ETC Slip Rings and Brush Replacements

Communique Number

MQUE-5BBGK2

LightSpeed QXi, CT/i, HSA

Drum Style Brush Block Part Cross-Reference

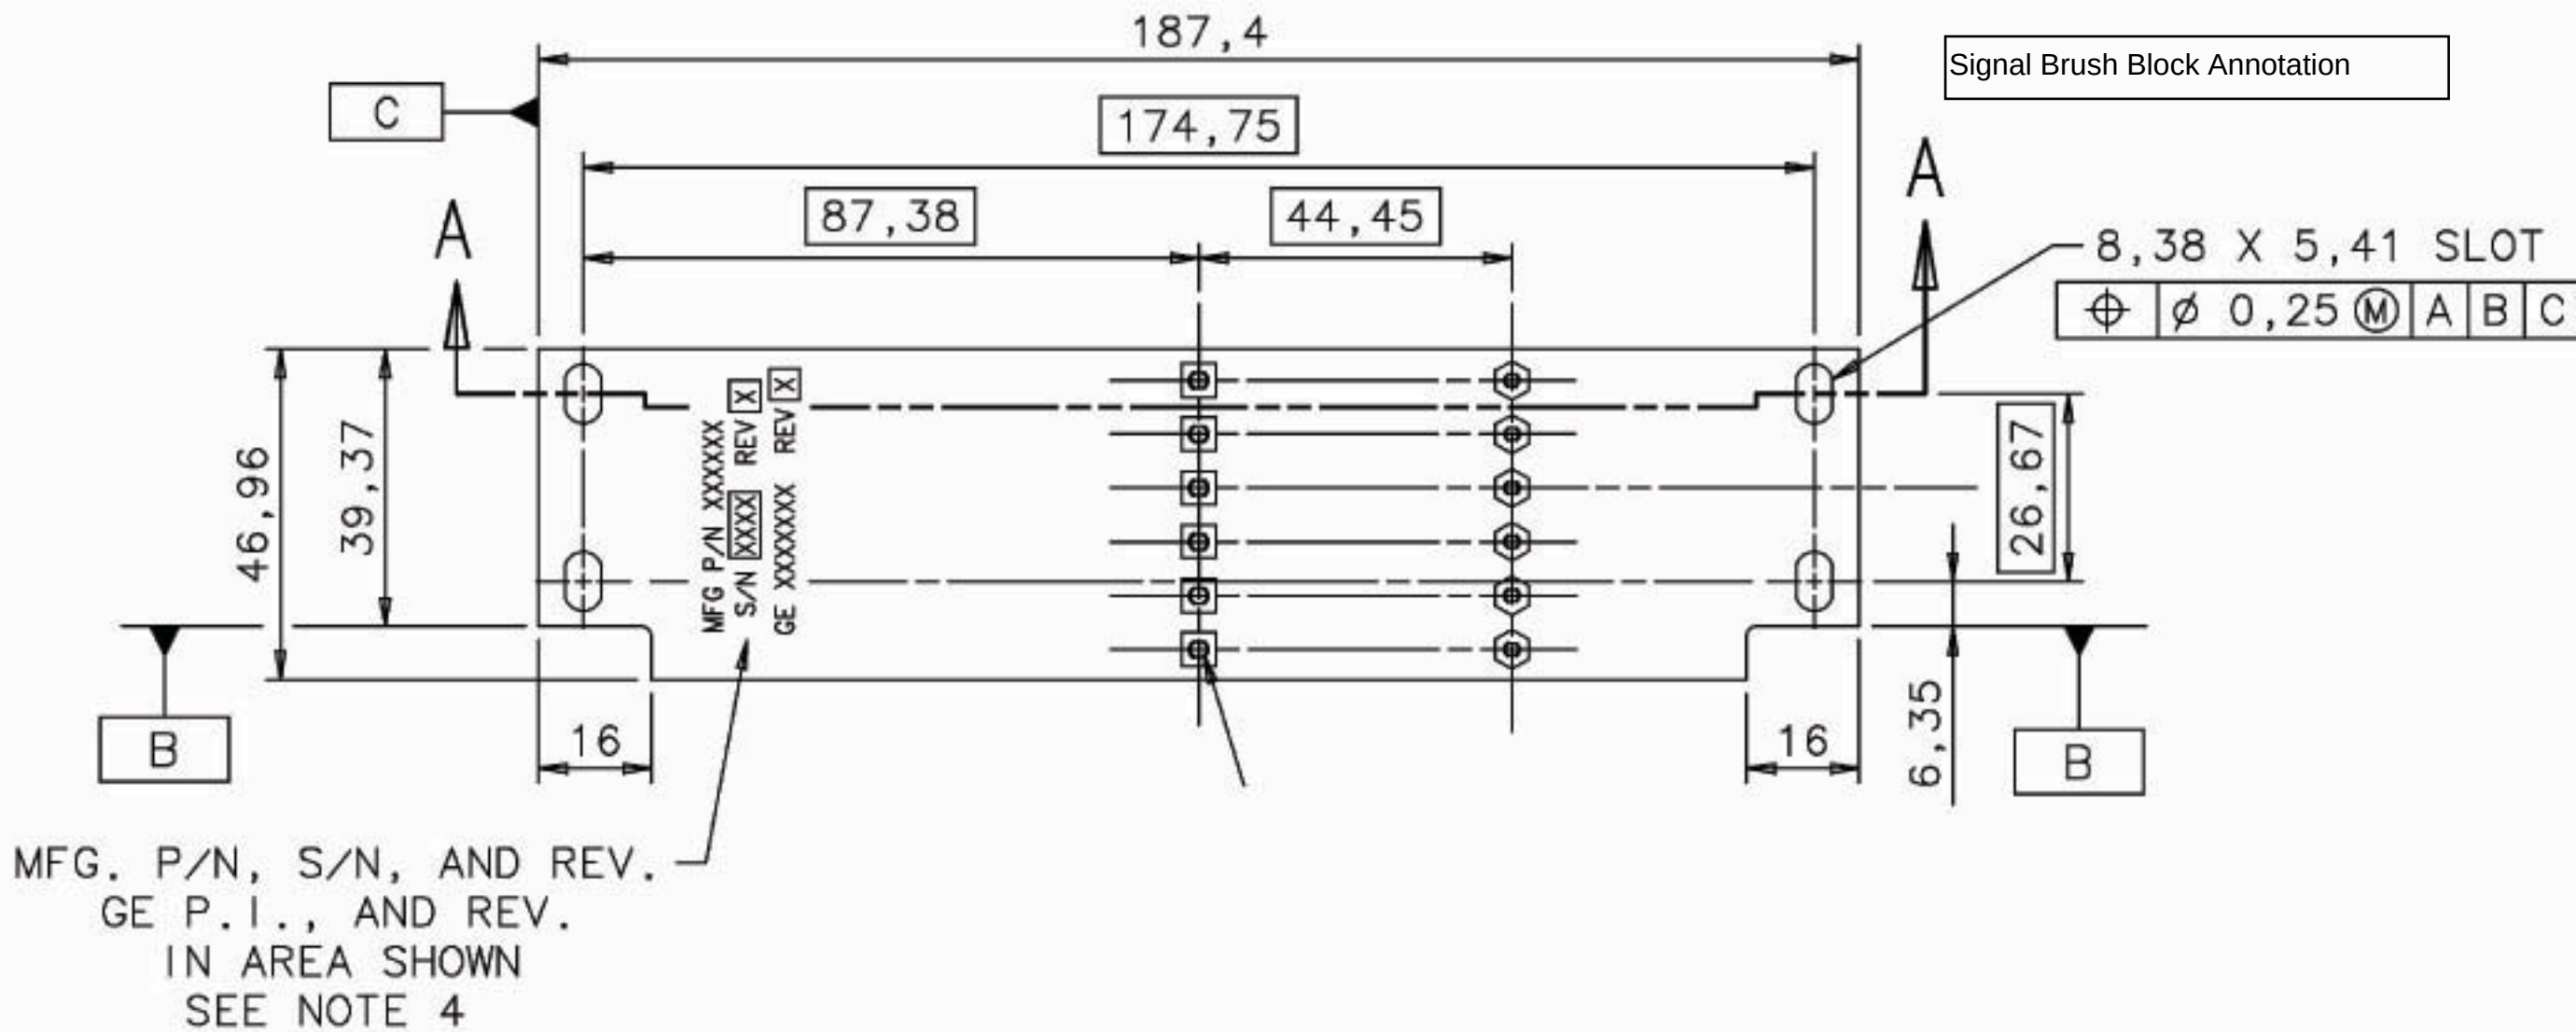
For HSA, CT/i, and LightSpeed QX/i, all of the brush part numbers have changed to the below:

Signal Brush Blocks (HSA, CT/i) – 2302509-2

Power Brush Blocks (ALL) – 2302508

Signal Brush Blocks (LightSpeed QX/i) – 2302509

If you are sent a mixed batch, that is, some brushes made by Schleifring and some made by ETC, do not install them. **Do NOT mix brushes from the two manufacturers on the same ring.**

Power Brush Block Annotation

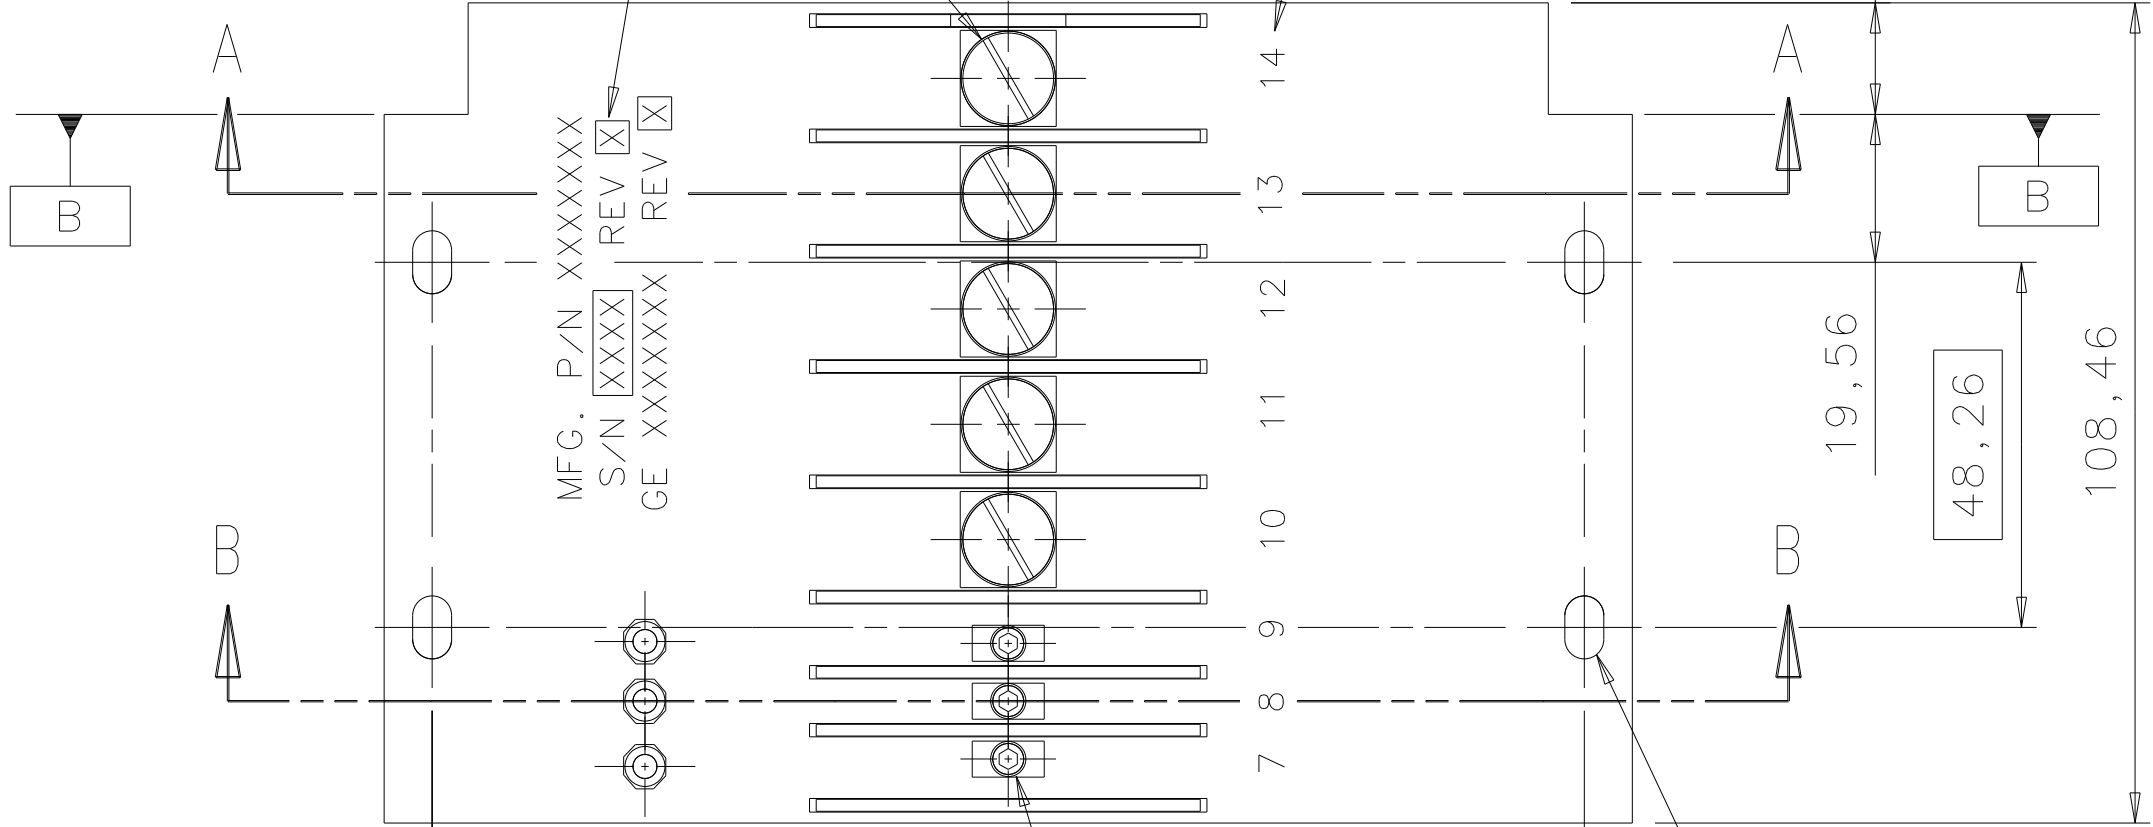
DO NOT MIX THESE BRUSHES ON THE SAME RING. USE EITHER ALL SCHLEIFRING-MADE BLOCKS OR ETC-MADE BLOCKS. If mixed on the same ring, the Schleifring brushes will experience increased wear due to excessive debris deposits from the ETC brushes. A matrix showing the cross match between these brushes is attached for your reference. If you are uncertain how to identify your brush, see the attached brush block identification guide - the MFG variable will say "Schleifring," and "ETC" for the two manufacturers of these brush blocks.
